**SECOND RESPONSE TO REQUEST FOR ADDITIONAL INFORMATION  
PERMIT TO OPERATE COMPOSTING FACILITY  
PERMIT TO CONSTRUCT LEACHATE TREATMENT FACILITY  
PERMIT TO OPERATE RESOURCE RECOVERY FACILITY  
WASTE TIRE GENERAL PERMIT  
AND  
PERMIT TO MAINTAIN CLOSED CLASS I SANITARY LANDFILL  
PREPARED FOR**

Mr. Kim B. Ford, P.E.  
Solid Waste Section  
Division of Waste Management  
Florida Department of Environmental Regulation  
4520 Oak Fair Boulevard  
Tampa, Florida 33610-7347

**RE: SUMTER COUNTY SOLID WASTE FACILITIES**

**PERMIT NO.:**      **S060-211179 - SOLID WASTE COMPOSTING**  
**WT60-211205 - WASTE TIRE STORAGE**  
**S060-211182 - M.R.F.**  
**SF60-211255 - LONG-TERM CARE**  
**SC60-211181 - LEACHATE TREATMENT**

**MONITORING WELL INFORMATION**

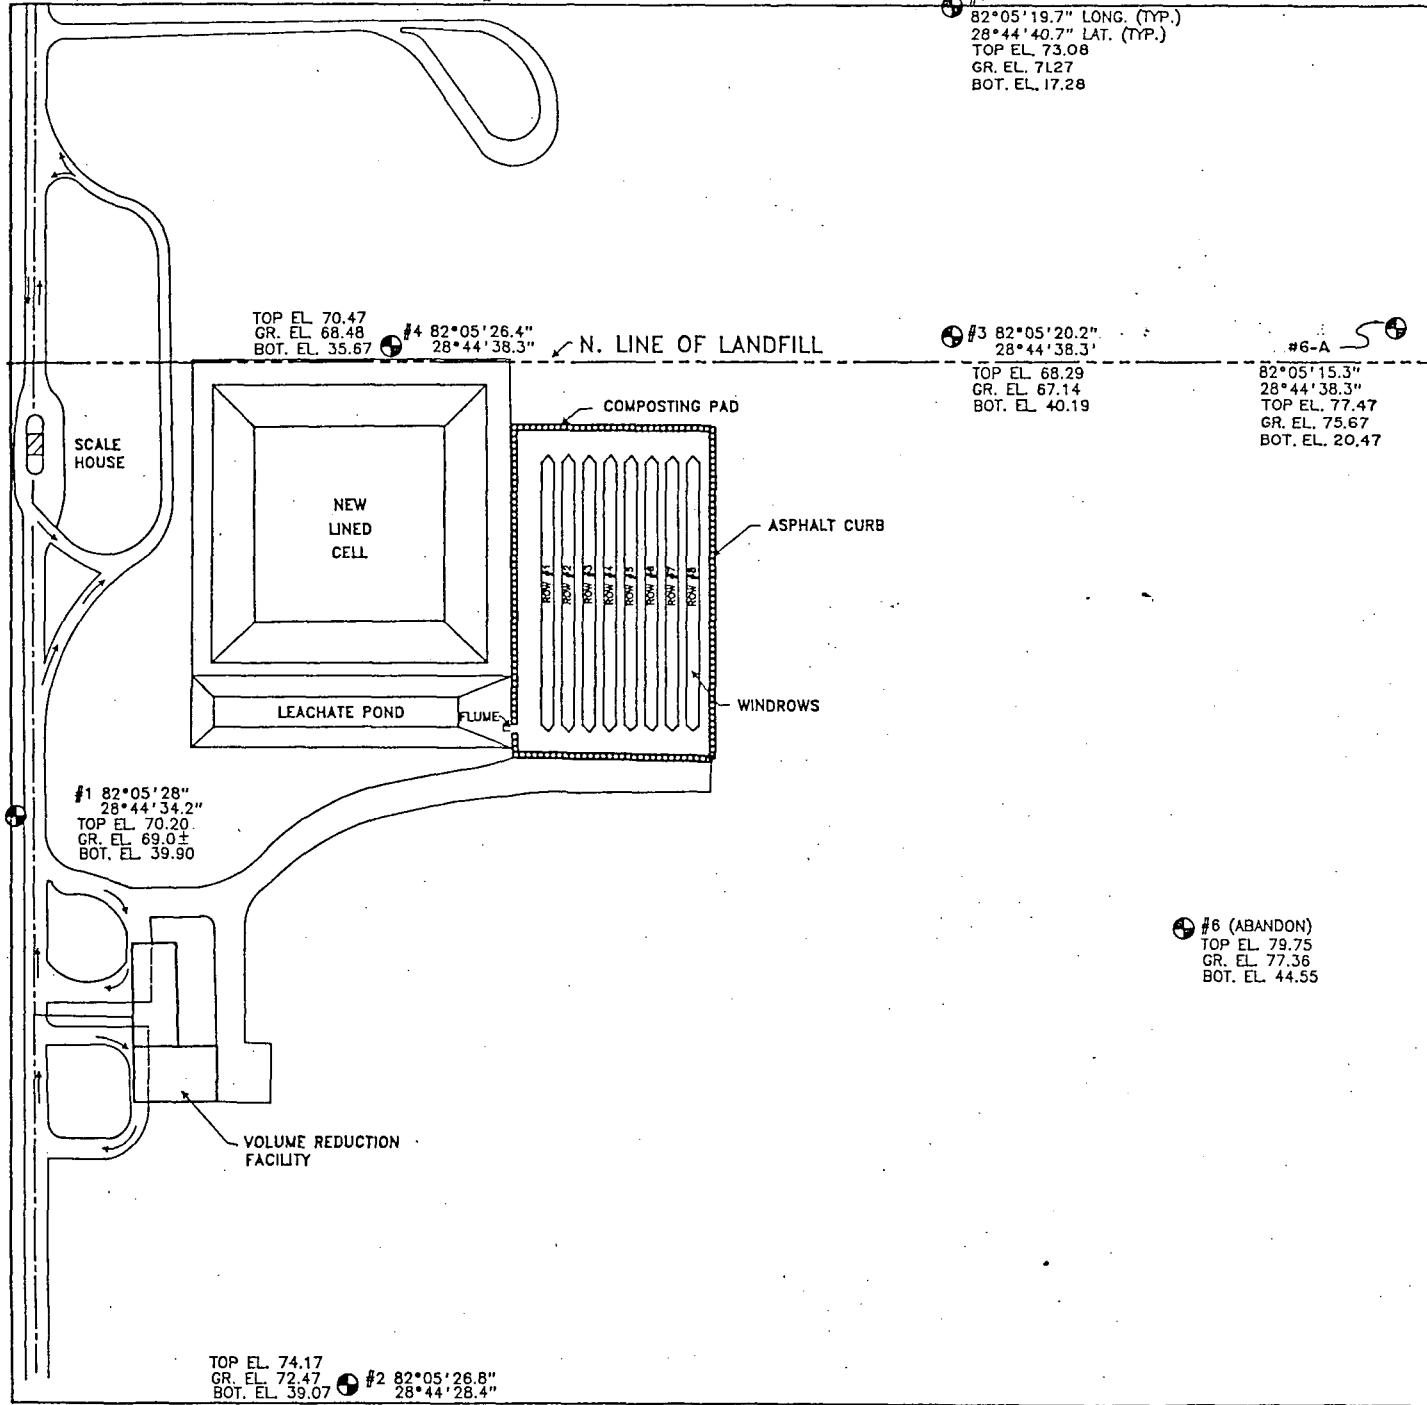
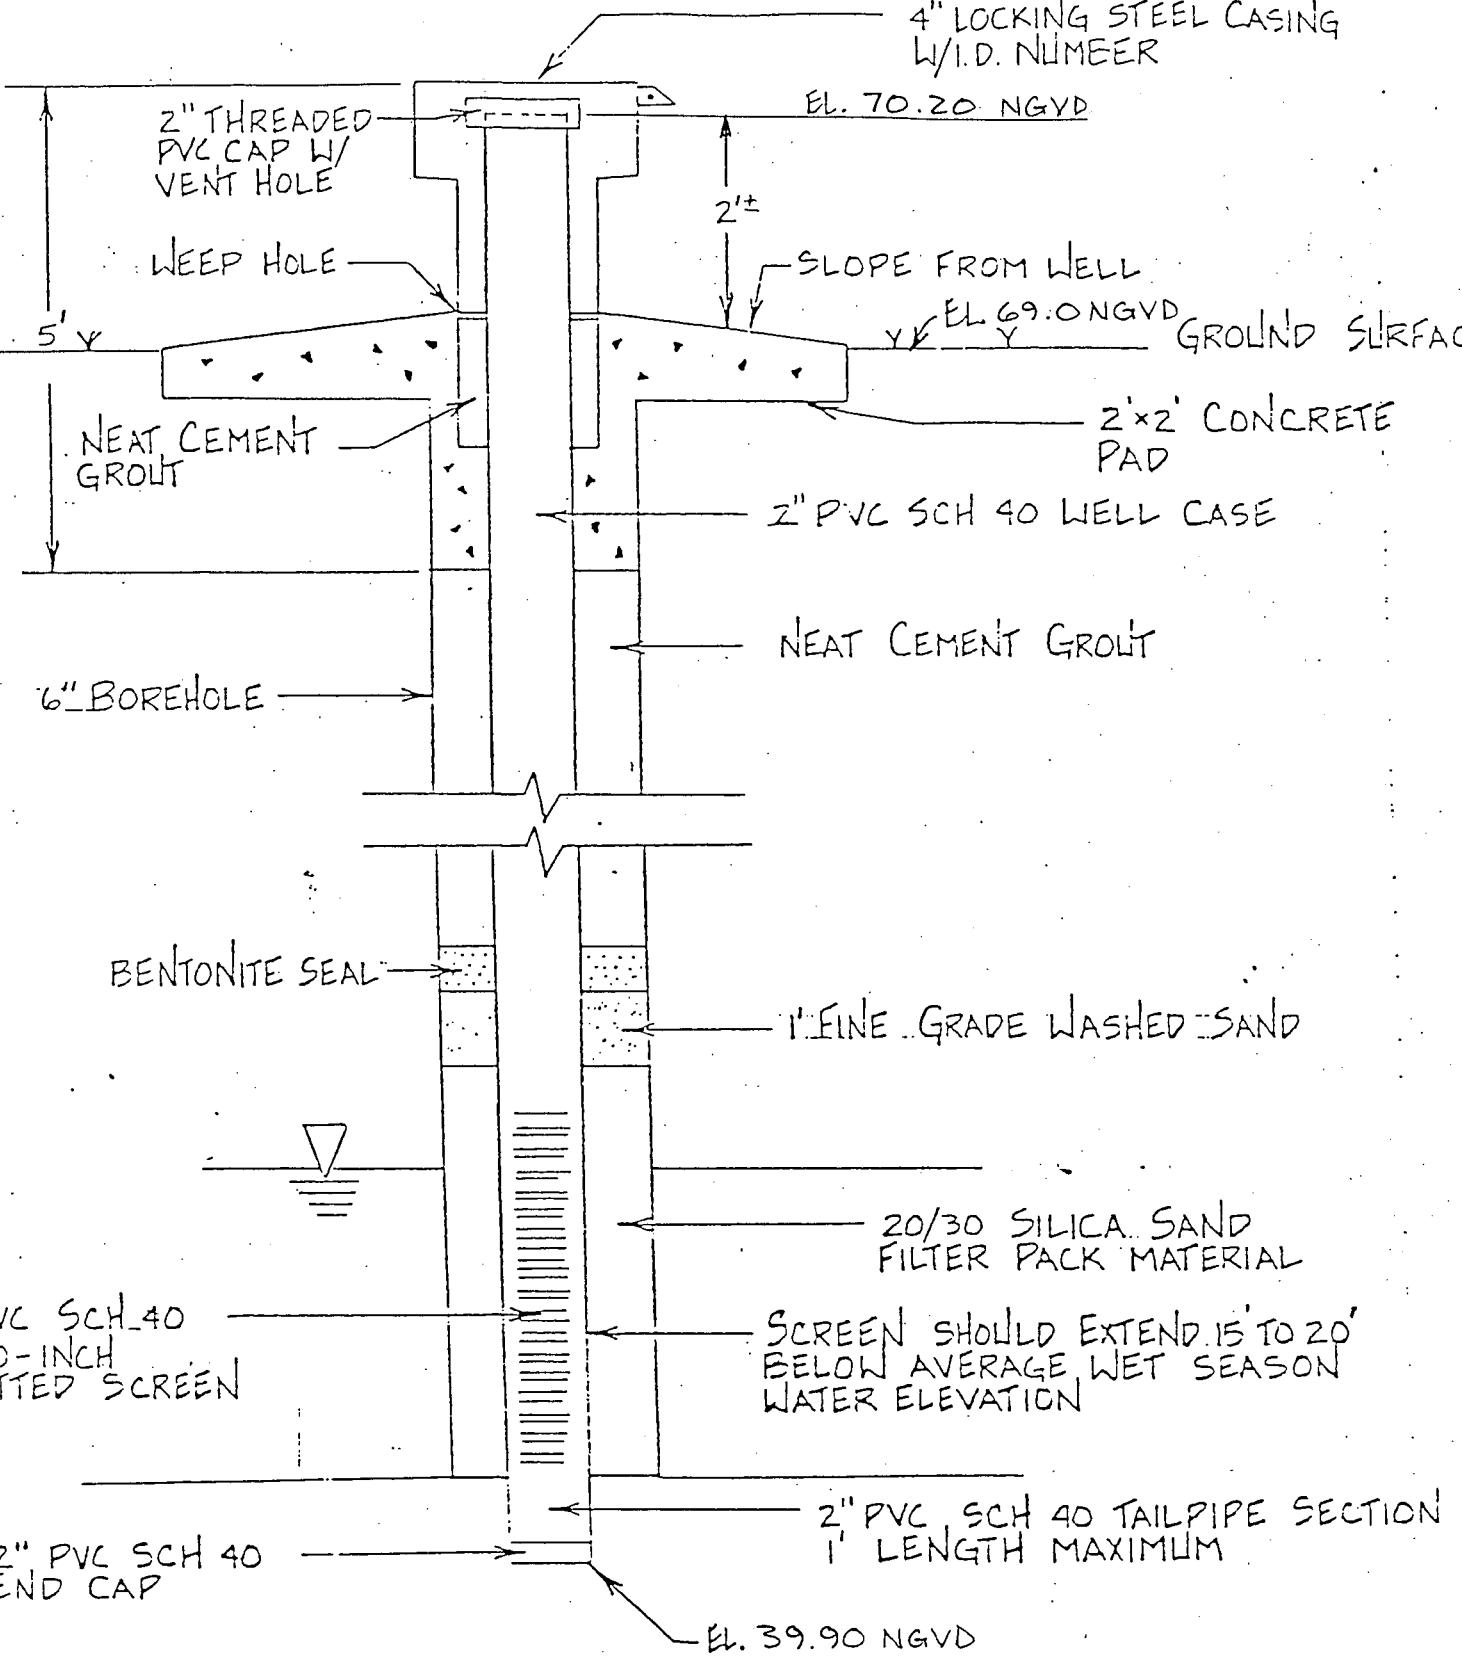
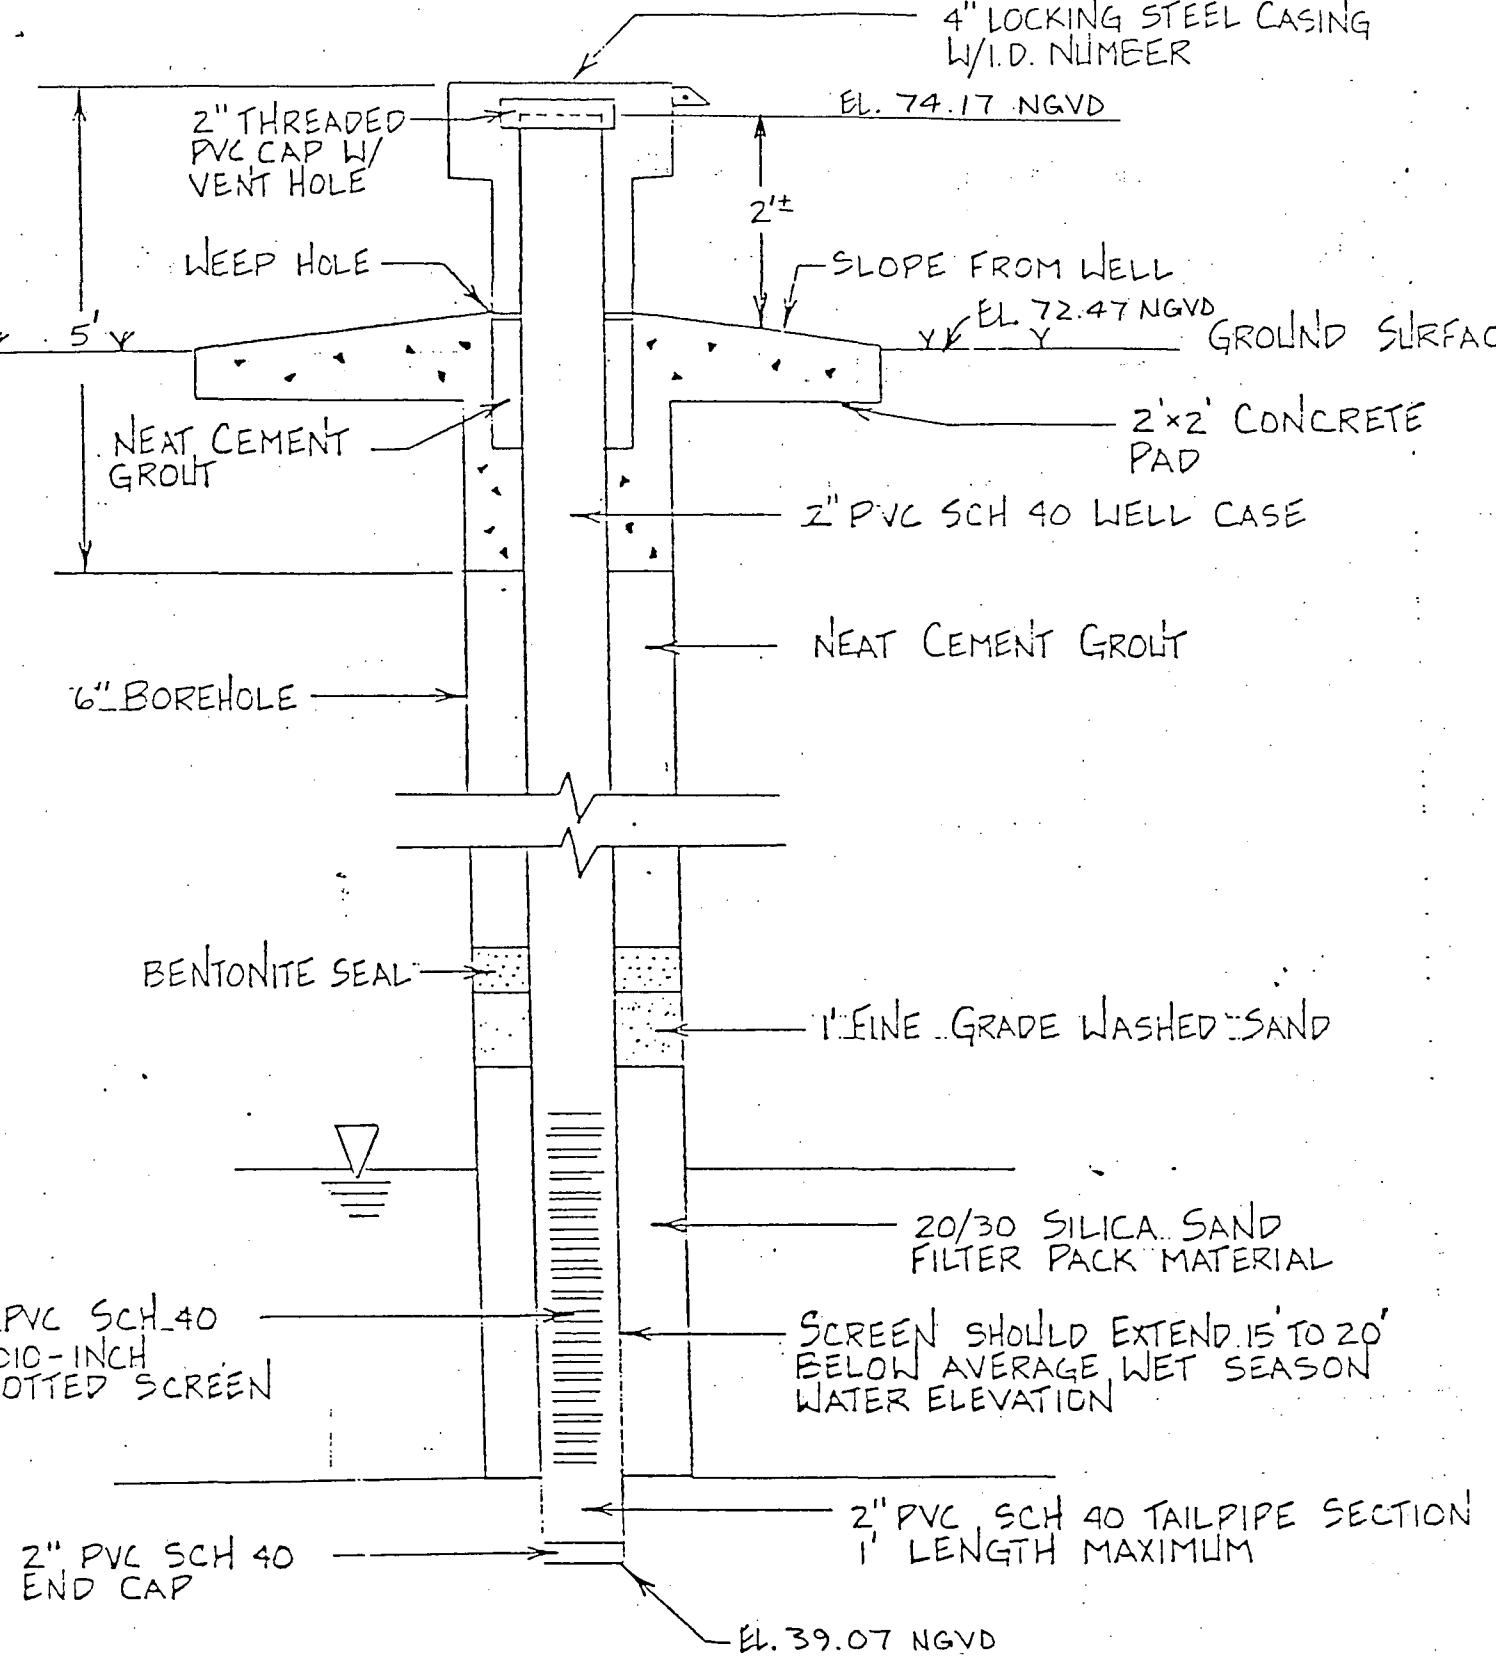
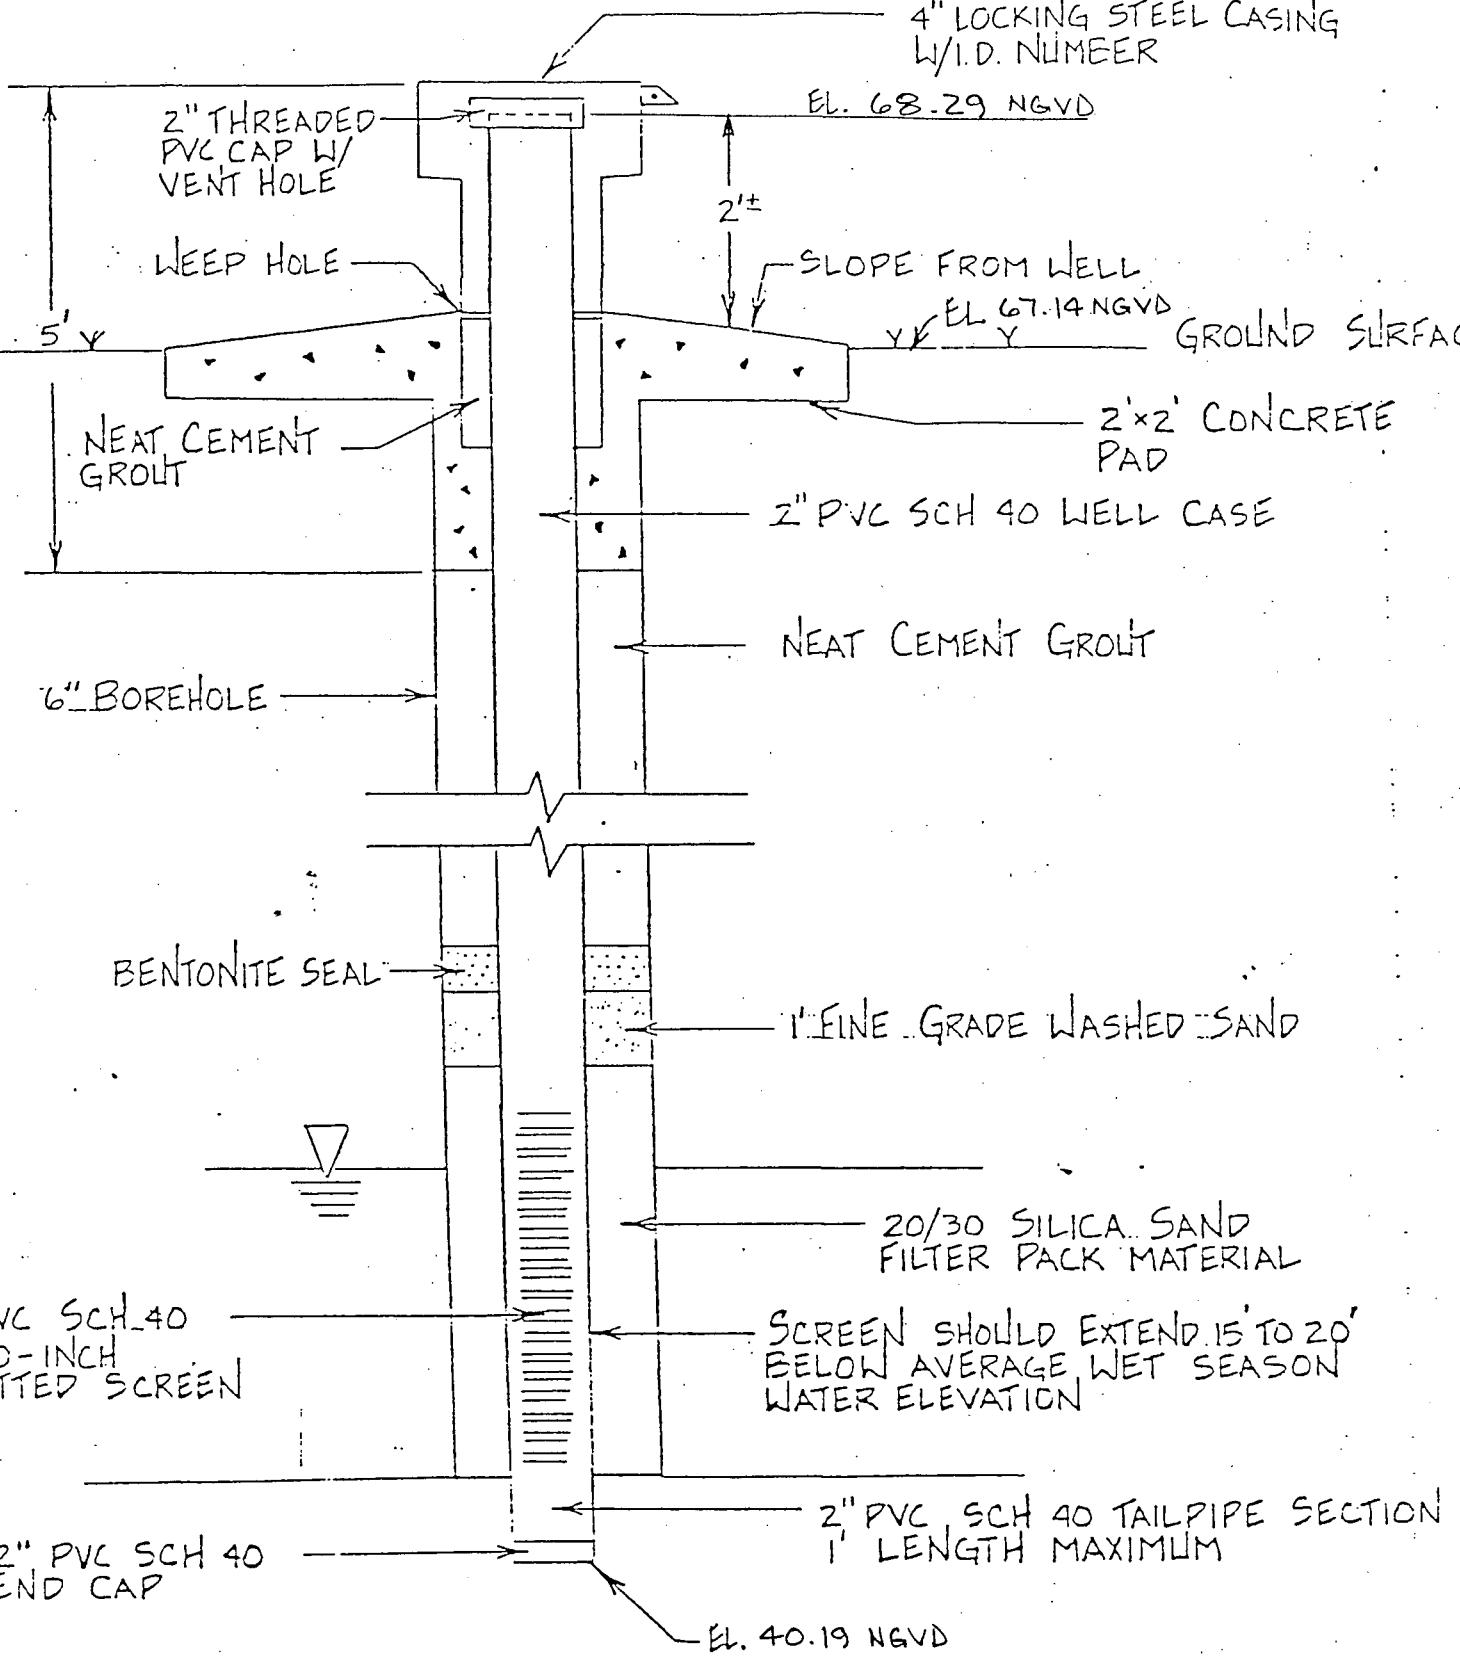
1. A monitor well construction detail was provided which indicates that the wells were constructed

with 2 foot screens and no bentonite seal between the screen and the cement seal. According to the Appendix E of the Environmental Compliance Branch Standard Operating Procedure and Quality Assurance Manual for the U.S. Environmental Protection Agency which deals with well construction, a well screen less than 5 feet shall not be employed except for temporary monitor wells. It is also stated that a seal is to be placed on top of the filter pack which consists of a high solids, pure bentonite material. The specific construction details for all monitor wells should be provided.

1. The well construction detail presented in our response dated May 29, 1992 was inadvertently taken from the original submission of the Groundwater Monitoring Plan, dated June 14, 1984, previously submitted to FDER and later revised at the request of FDER. The length of the screened interval was shown as being two (2) feet. This is inconsistent with the well completion reports prepared for the Southwest Florida Water Management District (SWFWMD) and the special well completion reports prepared for this project. The screened interval reported installed was five (5) feet. We suggest that the well completion reports be reviewed instead of the previously submitted well construction detail. The well completion reports and well construction details for each monitoring well are enclosed in Appendix B for your review and use.

A bentonite seal was installed above the filter pack material.
